CHANGE ORDER NO.

PROJECT: Flamson MStemporary Campus
Paso Unified School District

RE: Flamson Temp Campus
CCD 03 Grading and Utility Revisions (CPR's 02, 07R1)
Change Order Request: COR 03

Project Name: Flamson MS - Temp Campus/Interim Housing
Construction Change Document No. 03

Sheet C1 Change Description List:

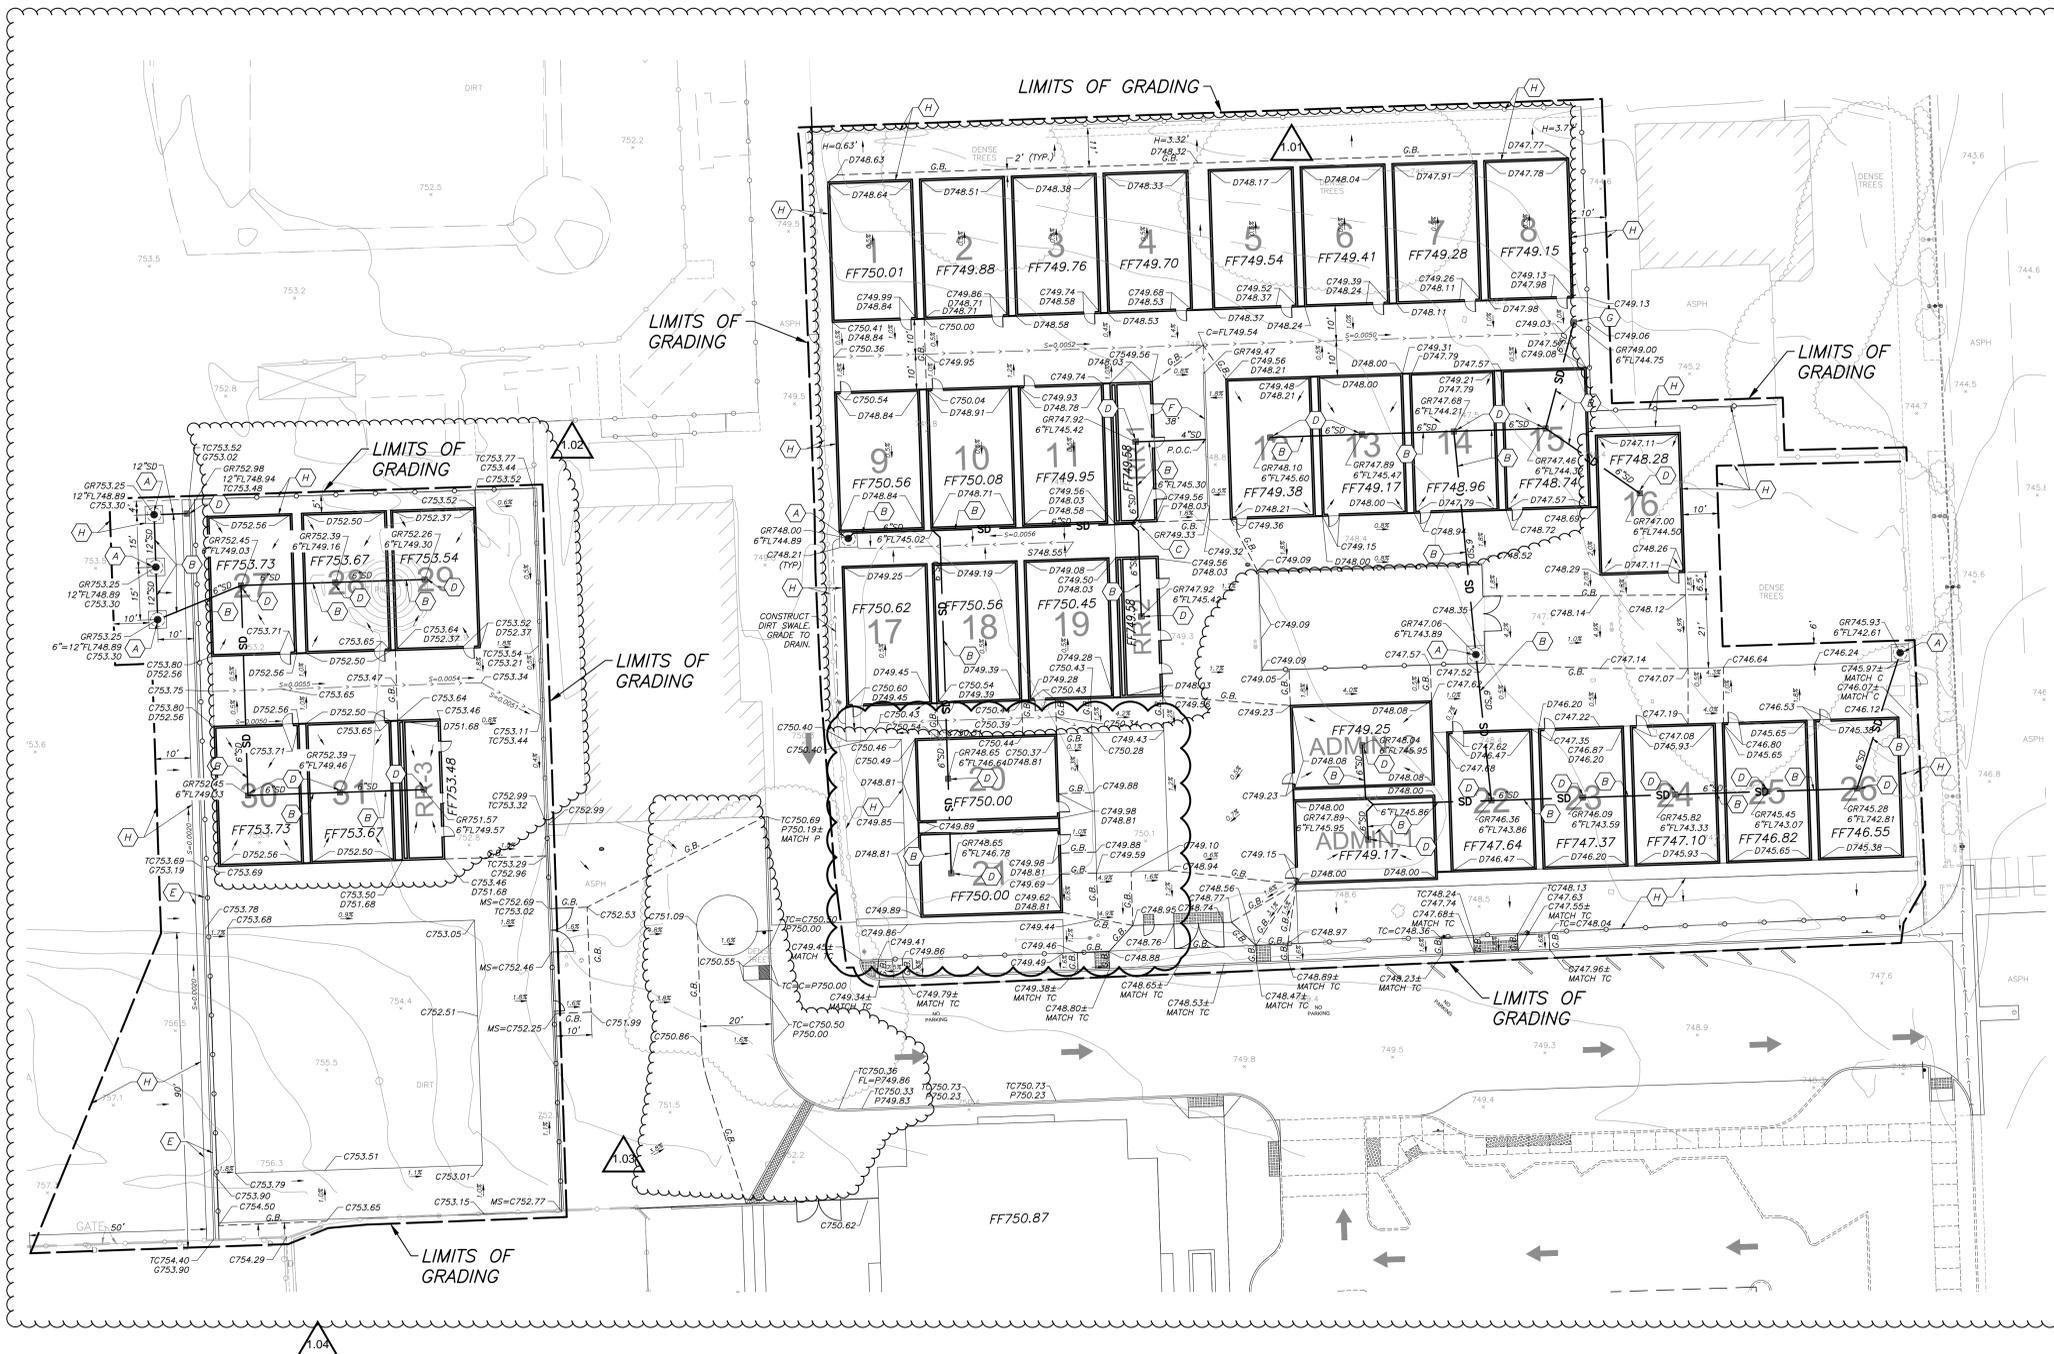
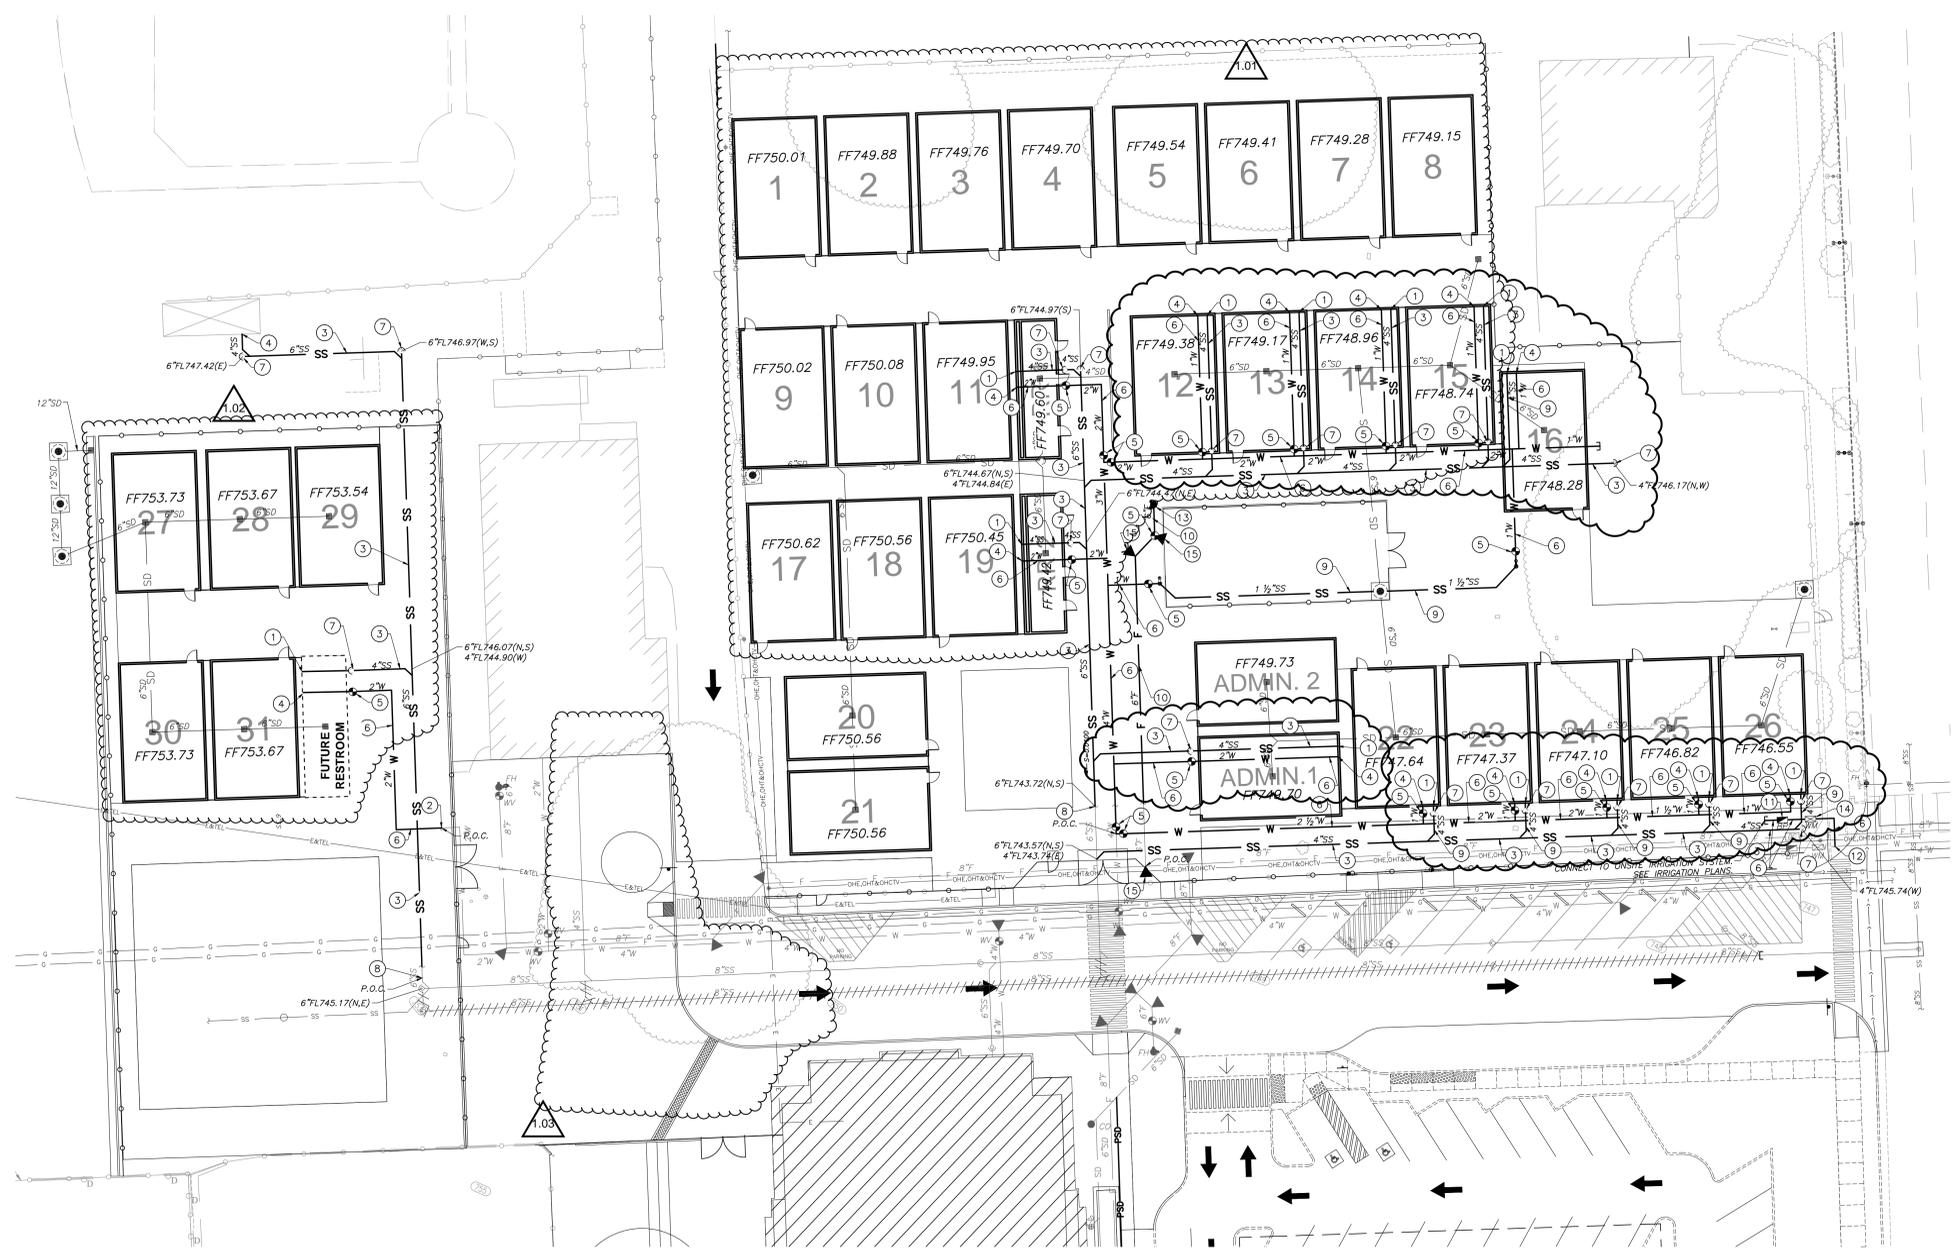
- 1.01 Modular buildings 1 through 19 shifted 3'-0" South to allow for a 3'-0" wide leveled surface area North of units 1 through 8 in accordance with code sections CEC/NEC 110 and CBC 1808.
- 1.02 Modular buildings 27 through 31 shifted 10'-0" South to allow for a minimum 20'-0" separation from an existing structure north of modular buildings 27 and 28.
- 1.03 Added flatwork area East of modular building cluster No. 5. Refer to DSA Approved sheet AT.4 for cluster location
- 1.04 Overall grading adjustment due to modular building revised site layout.

- 1.01 Modular buildings 1 through 19 shifted 3'-0" south to allow for a 3'-0" wide leveled surface area North of units 1 through 8 in accordance with code sections CEC/NEC 110 and CBC 1808.
- 1.02 Modular buildings 27 through 31 shifted 10'-0" south to allow for a minimum 20'-0" separation from an existing structure north of modular buildings 27 and 28.
- 1.03 Added flatwork area East of modular building cluster No. 5. Refer to DSA Approved sheet AT.4 for cluster location.
- 1.05 Sanitary sewer line increase from 2" to 4" at modular buildings 12 through 16.
- 1.06 Sanitary sewer line increase from 2" to 4" at modular buildings 22 through 26 and added water and sanitary sewer connection to modular building Admin-1
- 1.07 Water and sanitary sewer revisions to drinking fountains.

7790 NORTH PALM AVENUE FRESNO, CALIFORNIA 93711 T 559.448.8400 F 559.448.8467 www.sim-pbk.com	PROJECT FLAMSON TEMPORARY CAMPUS	PROJECT No. 17-58
	SHEET DESCRIPTION ADDED 6" SLAB WITH #4 REBAR AT 18" O.C.	SCALE N/A
	DATE 07/11/2019 PROJECT MANAGER RAFAEL FERREIRA	SHEET NUMBER DET-4

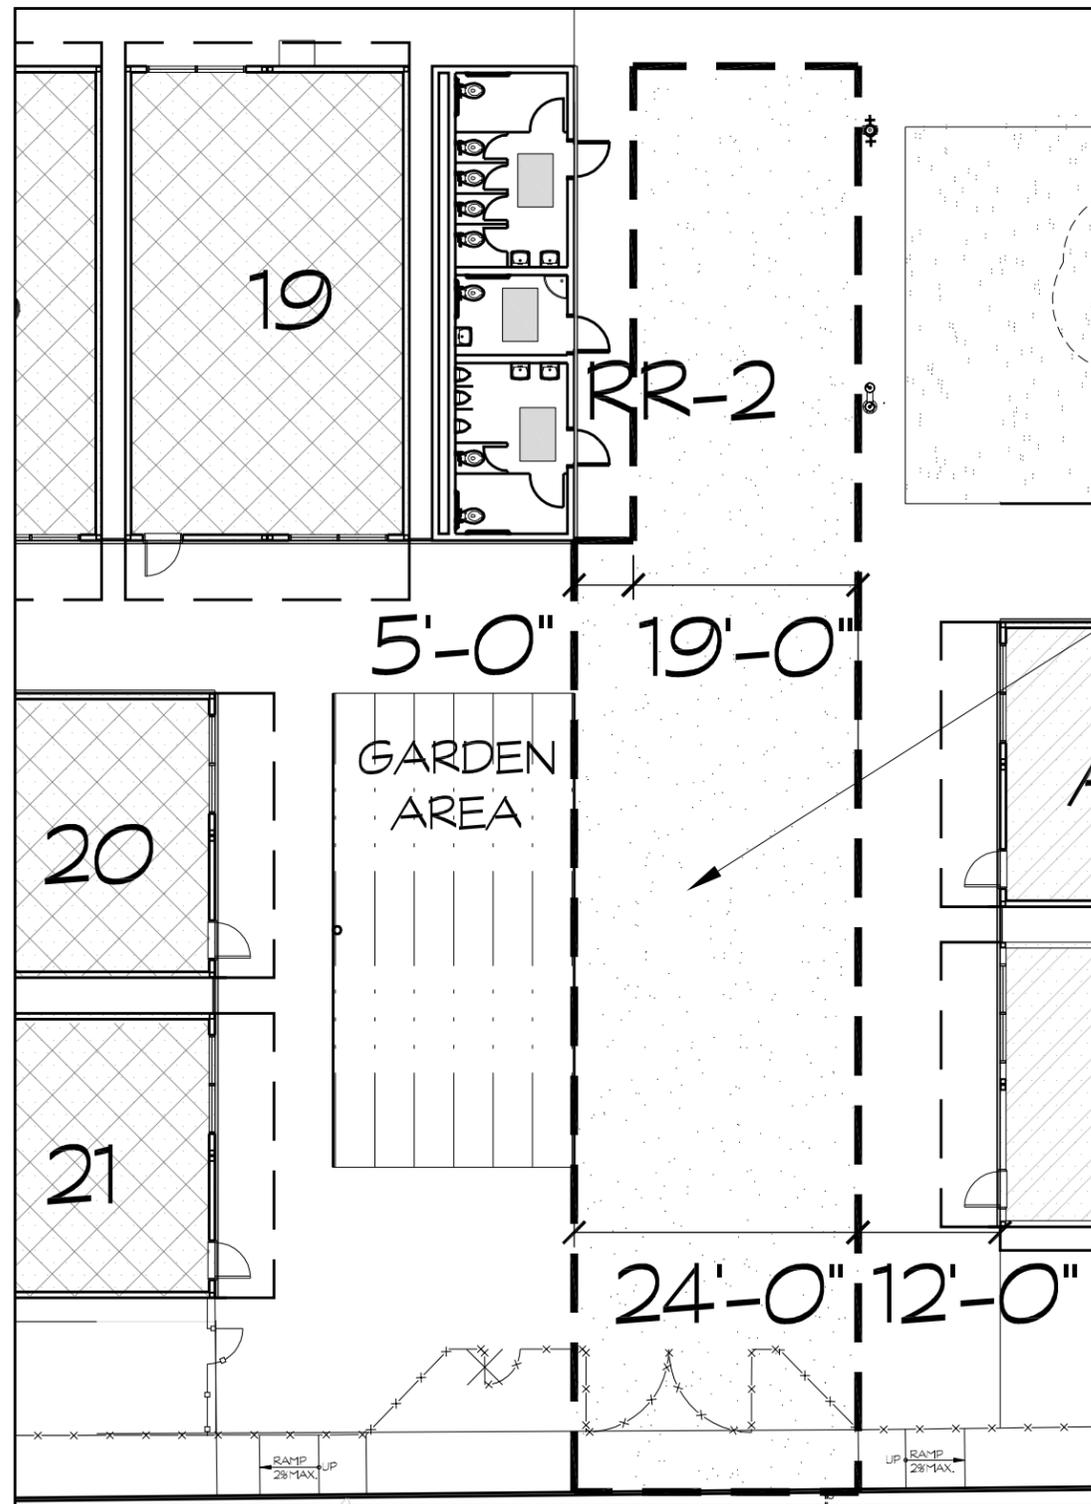
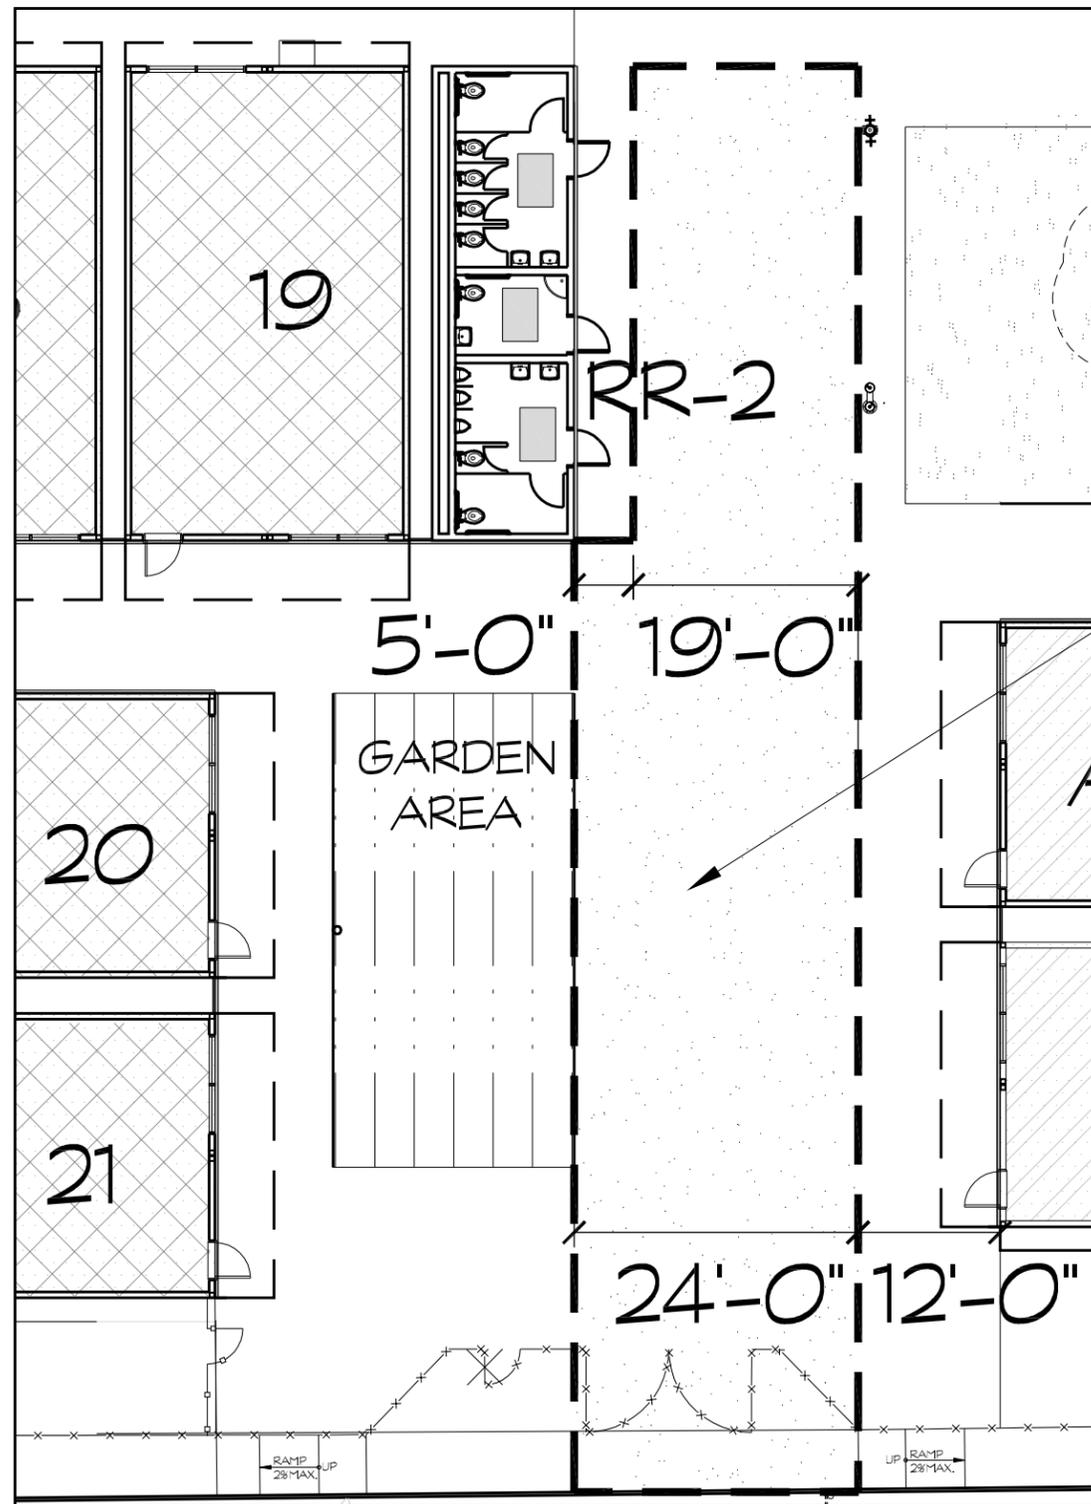
DESCRIPTION OF CHANGE: ADD DRIVE ISLE 6" THICK WITH #4 REBAR 18" O.C.

Description of Work: Contractor to provide pricing for added 6" slab with #4 rebar at 18" o.c. each way for vehicle access as indicated on the attached drawing.
